ADDENDUM NO. 1
Bid Due Date: 6/3/2026

Dated: 5/20/2026

McPherson Square Library Renovations and Park Improvements

**McPherson Square Library Renovations and Park Improvements RFP
Answers to Bidder's Questions
Addendum #1 5/20/26**

Figure 1: Image of cross section from existing drawings.

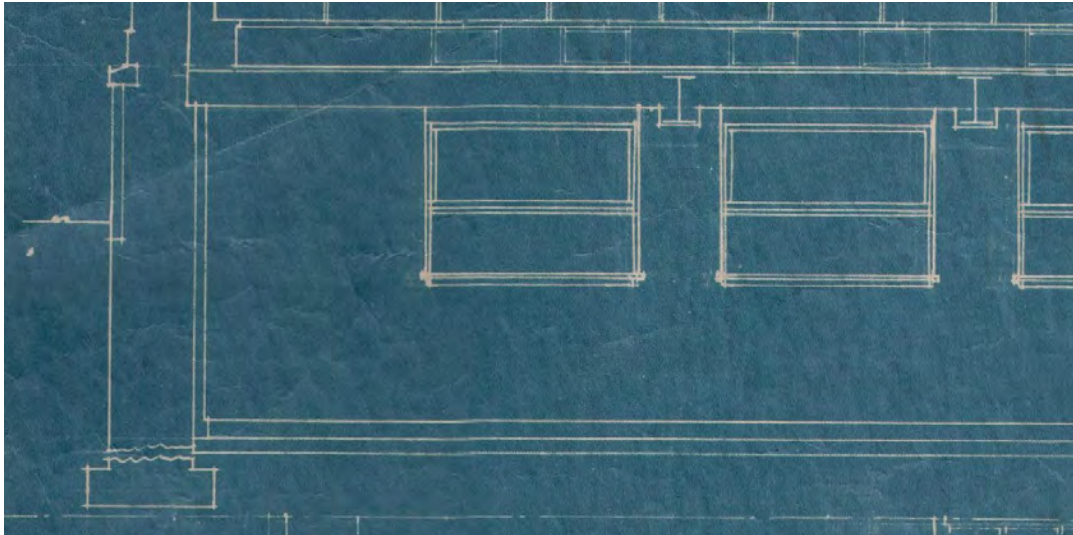
33. Please confirm the construction of the first floor - Is this wood-framed/sheathed, or is this a concrete slab? Please provide existing cross section detail.

Response: The first-floor framing consists of wood joists that frame to steel beams which are supported on masonry piers. The wood framing depth and spacing is unknown, but is assumed to be either 10" or 12" deep and are spaced at 16" or 24" oc. See 2/S2.1 First Floor Framing Plan for direction of joist framing. Existing Drawings from 1915 can be provided upon request (see image below).

C3.0 PCSM PROPOSED SITE PLAN – Clarification of Alternate 6 Paving Areas

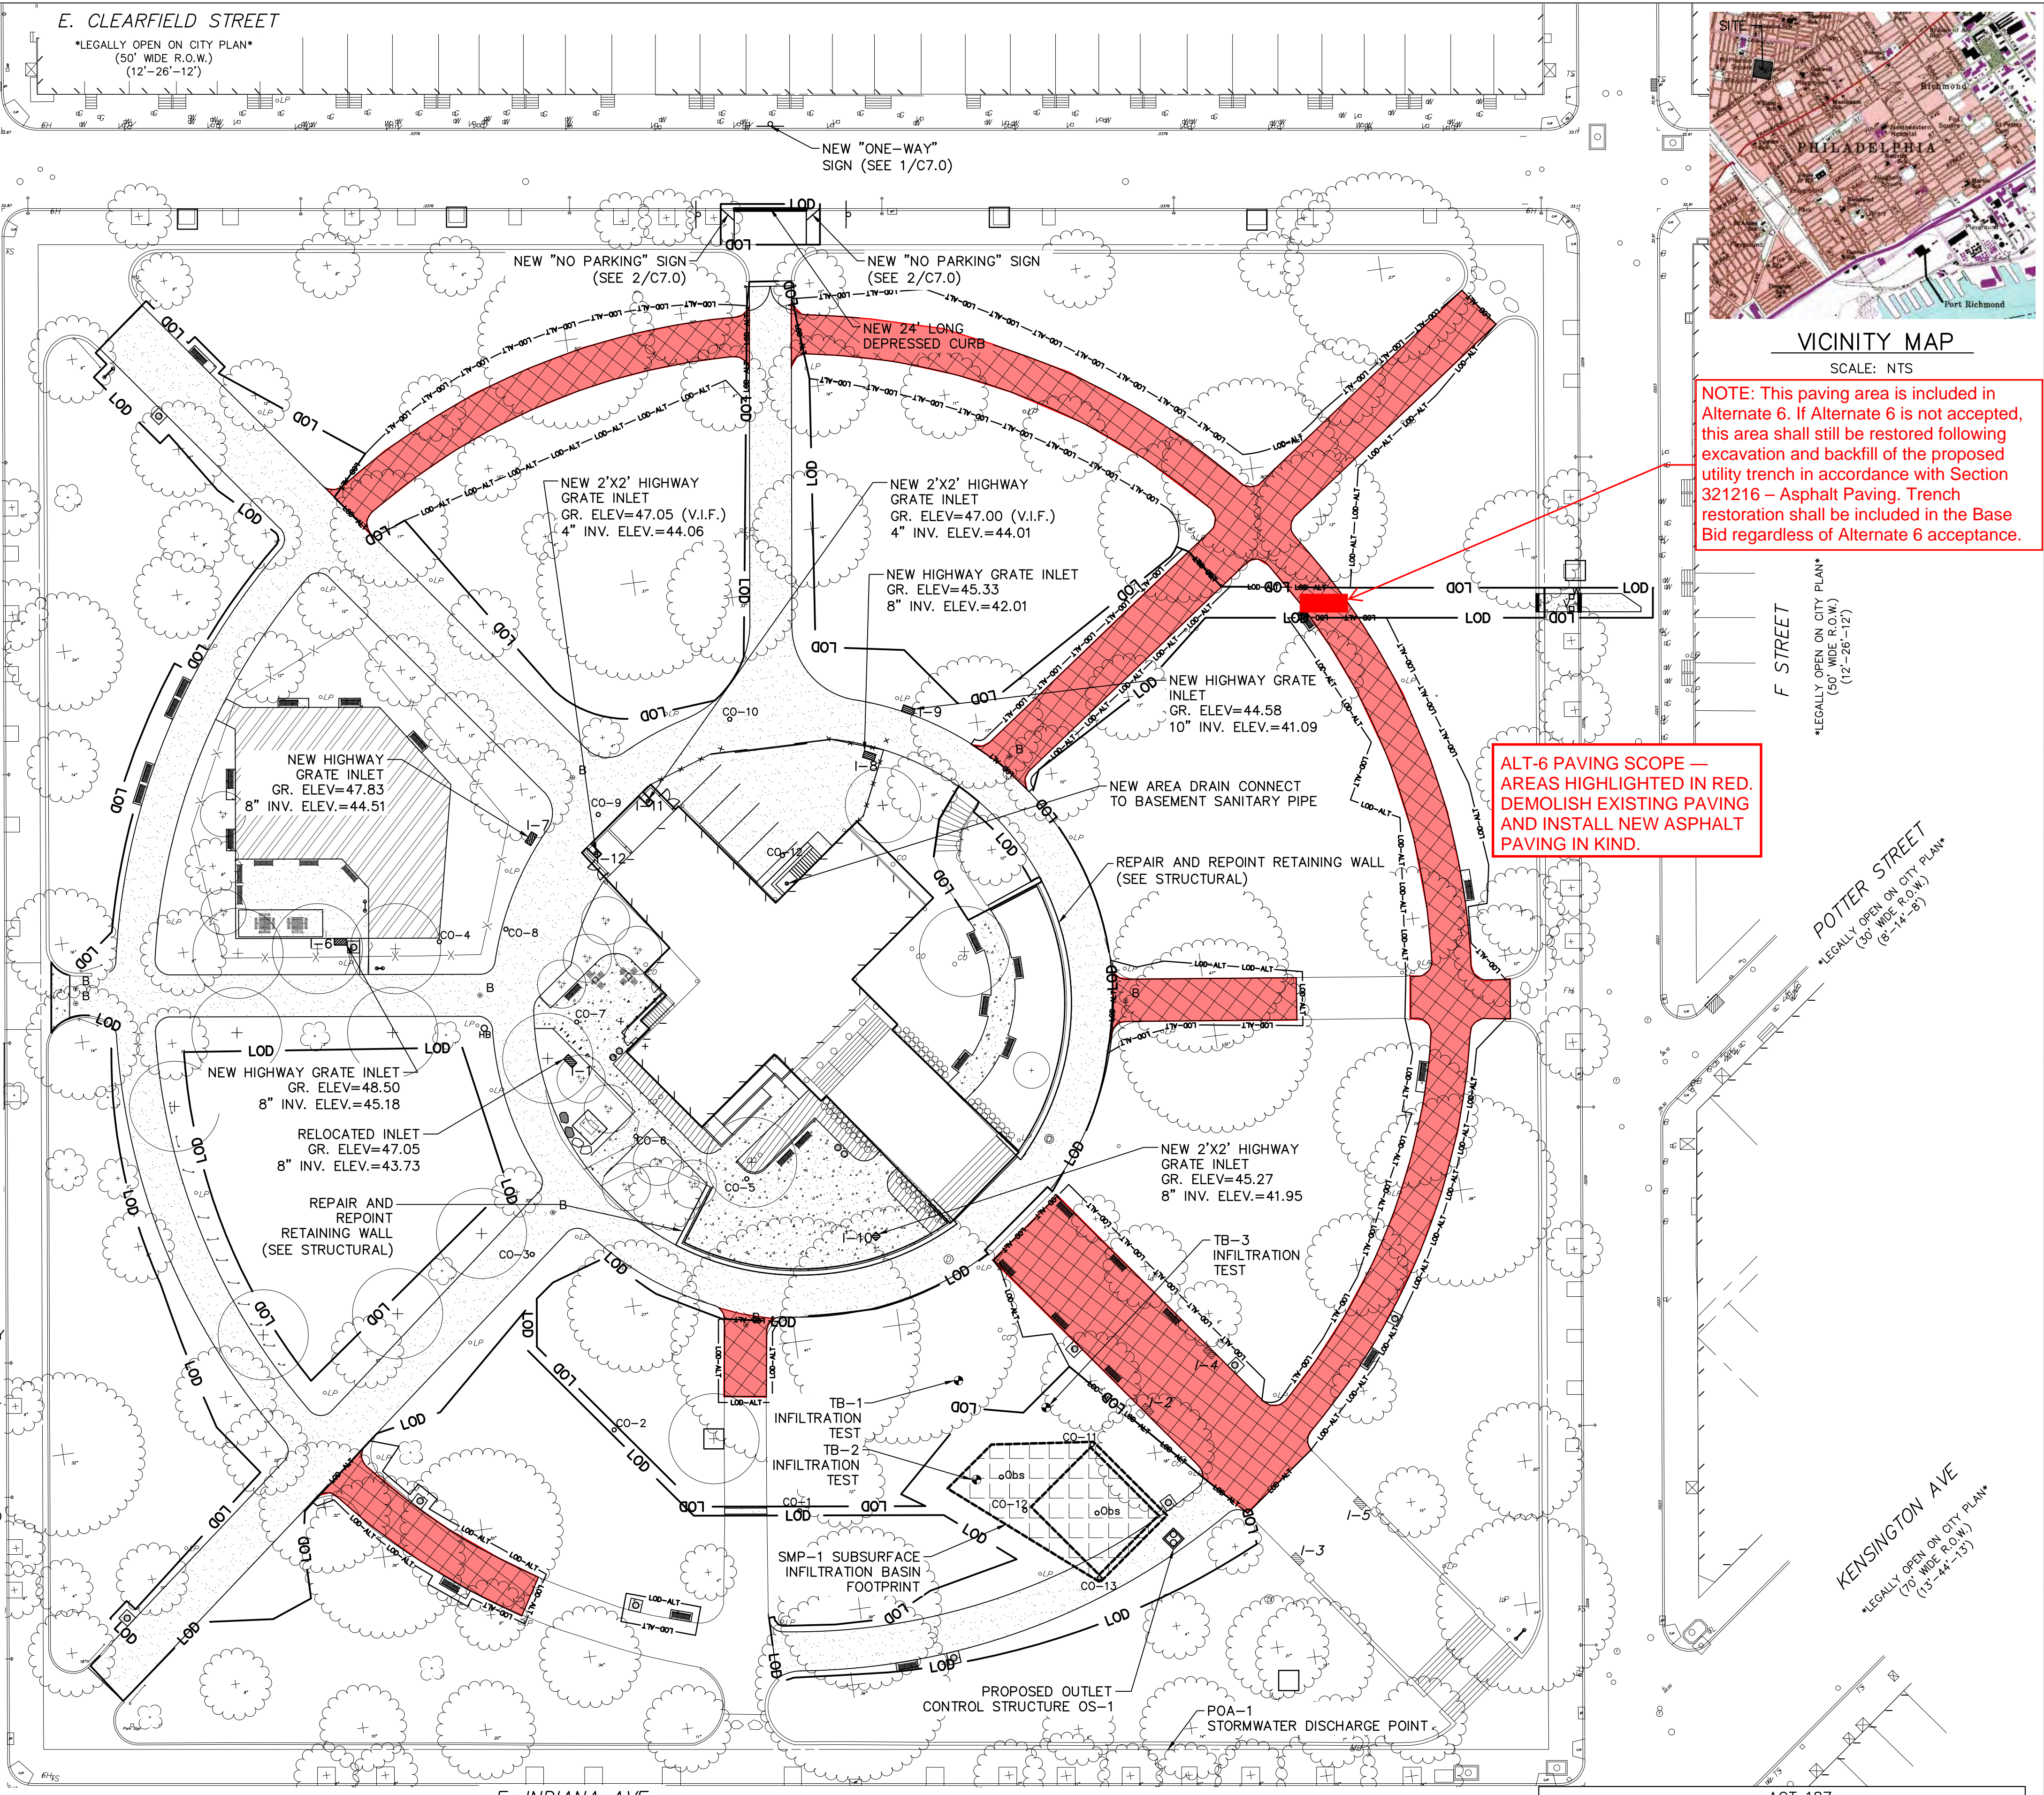
- **Refer to spec section 129300-Site furnishings for shade structure specifications.**
27. Regarding Alternate 6 - Please provide a marked-up plan indicating what work needs to be performed in the locations needed, the verbal description is inadequate for pricing purposes

Response:
- **Refer to L100 and L200 for Alternate 6 locations. They are identified with different hatches from the base bid hatch. The hatches are identified in the legends as Alternate 6. Additionally see C3.0 (attached).**

FOR REFERENCE ONLY — PRE-BID RFI RESPONSE.
ALTERNATE 6 PAVING AREAS HIGHLIGHTED IN RED. MARKUP ADDED TO ORIGINAL CONTRACT DOCUMENT. NOT FOR CONSTRUCTION. REFER TO ORIGINAL CONTRACT DOCUMENTS.

DRAWING TITLE
PCSM - PROPOSED GRADING PLAN

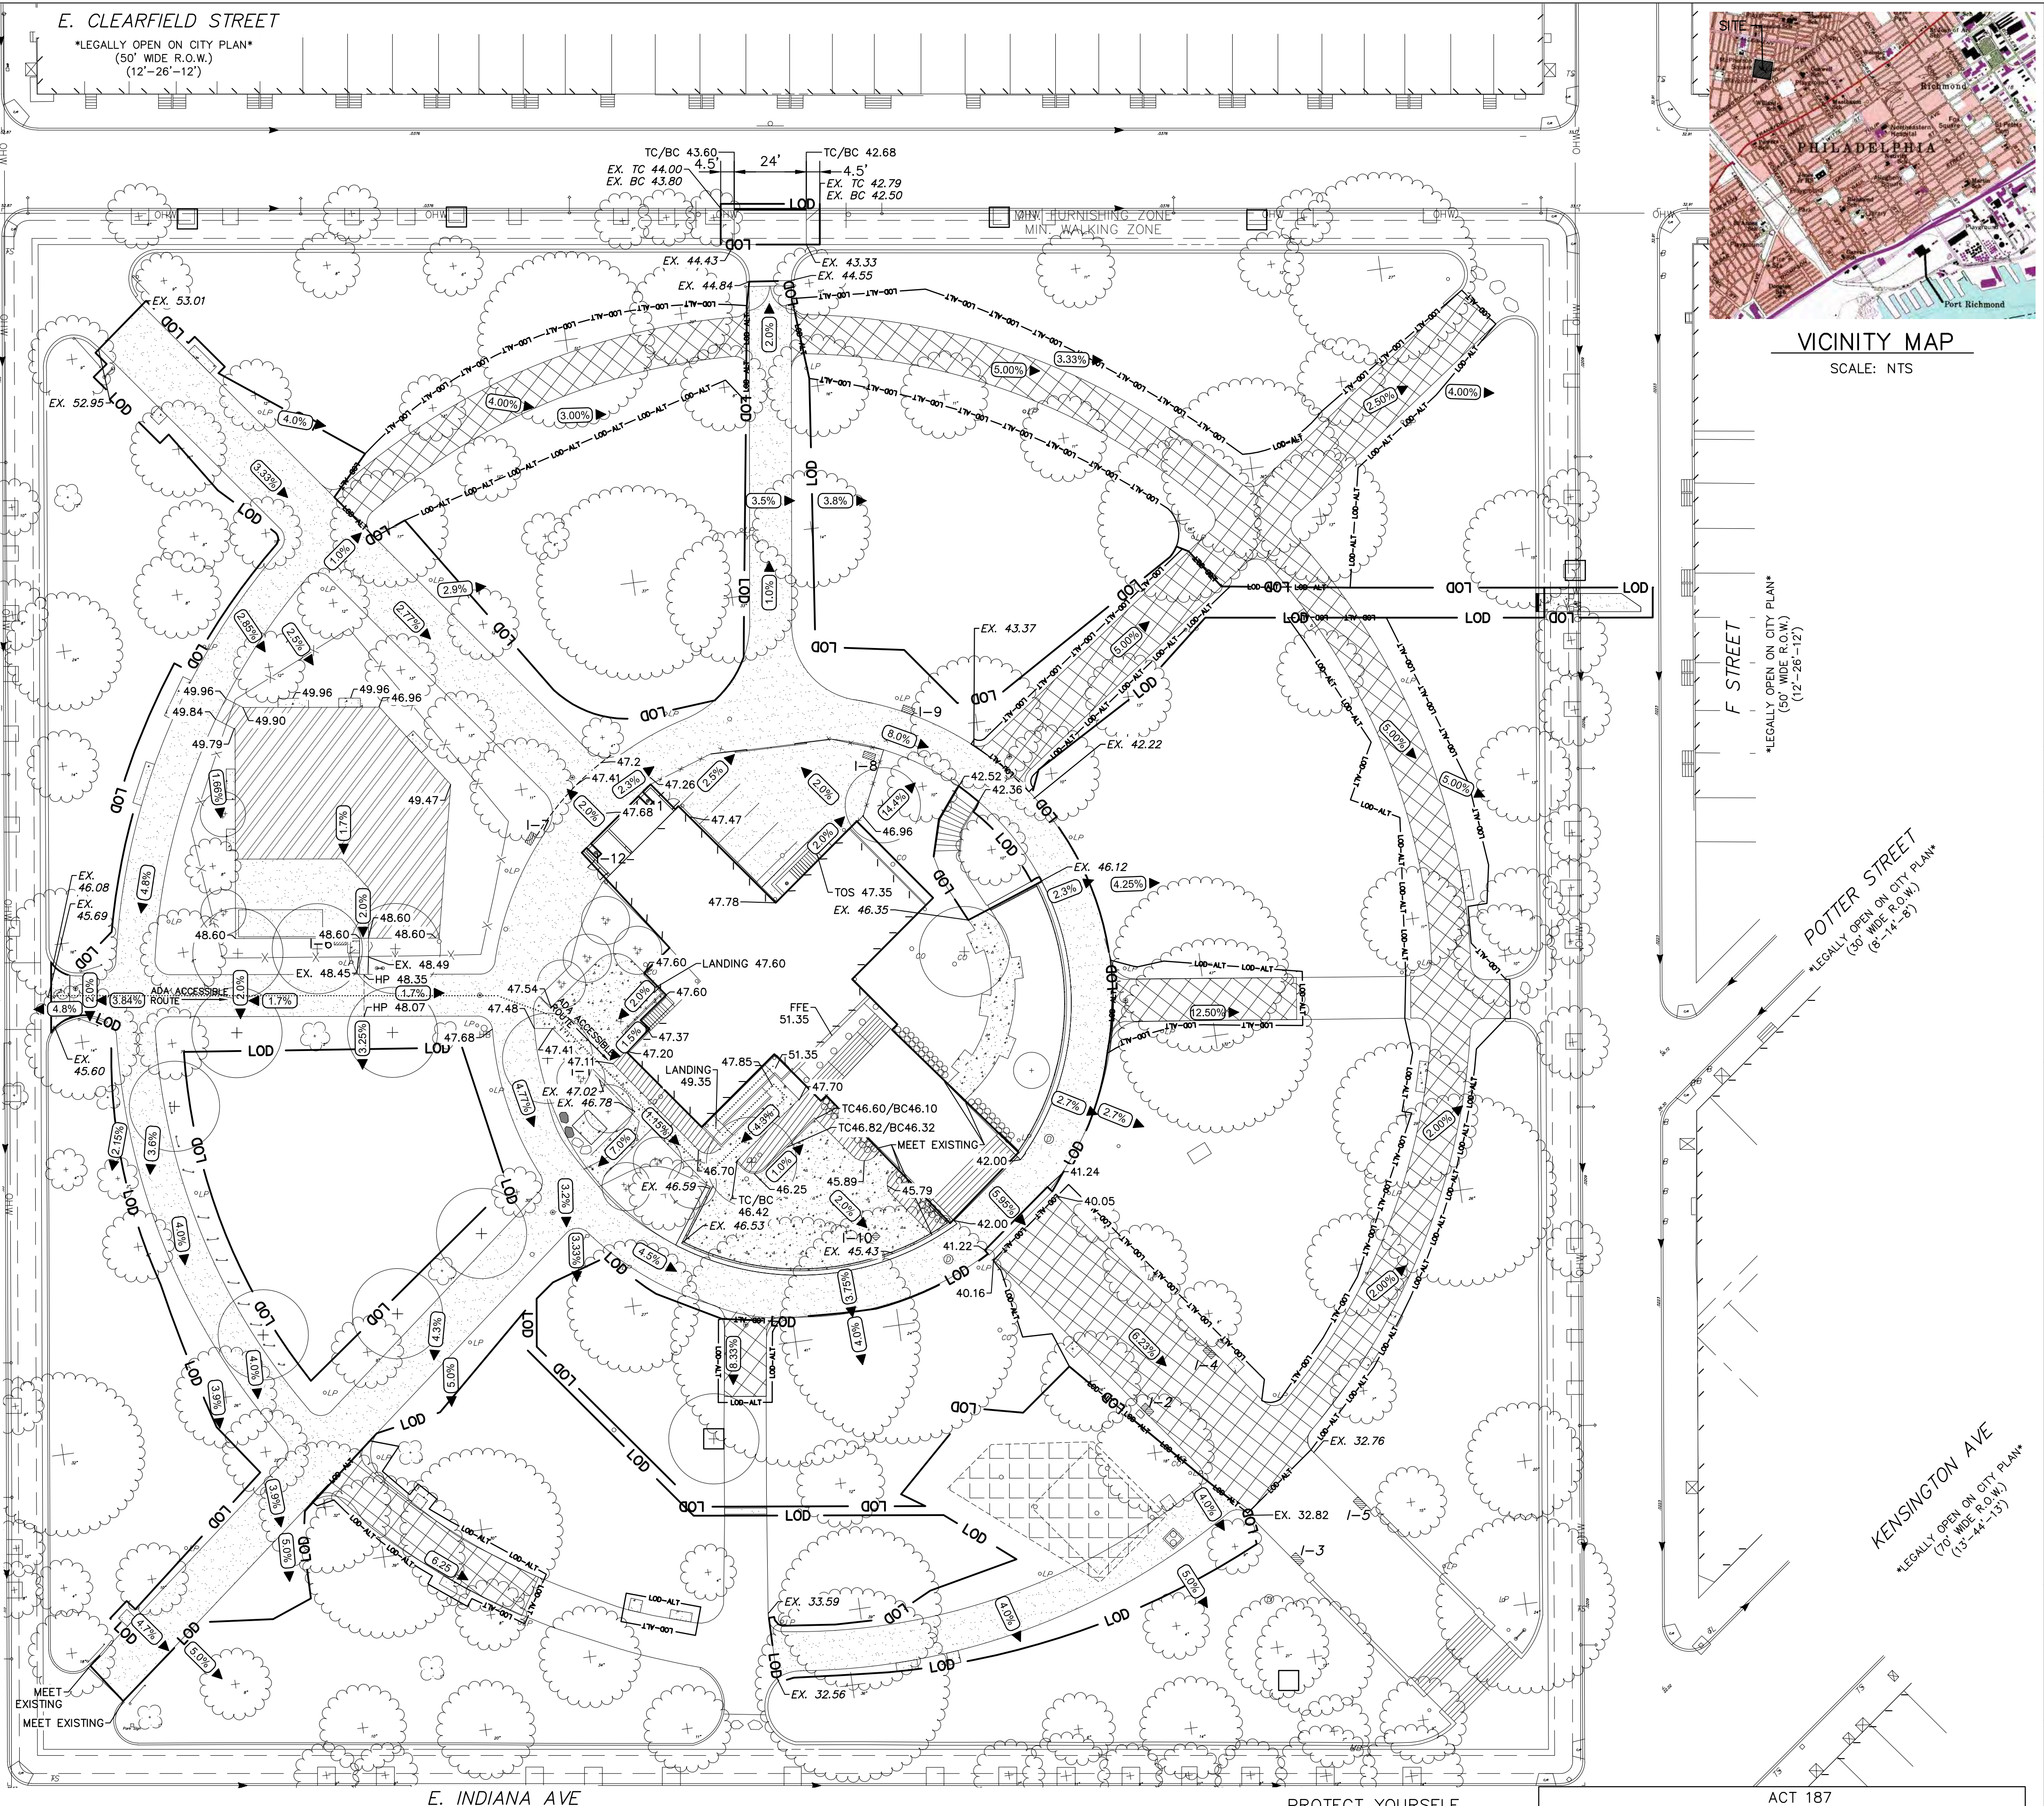
52. Please provide a copy of the Proposed Grading Plan C4.0 without elevation lines.

Response: Refer to C4.0 with elevation lines removed (attached).

SEALS
FOR REFERENCE ONLY — PRE-BID RFI RESPONSE. CONTOUR LINES REMOVED FROM ORIGINAL. NOT FOR CONSTRUCTION. REFER TO ORIGINAL CONTRACT DOCUMENTS.
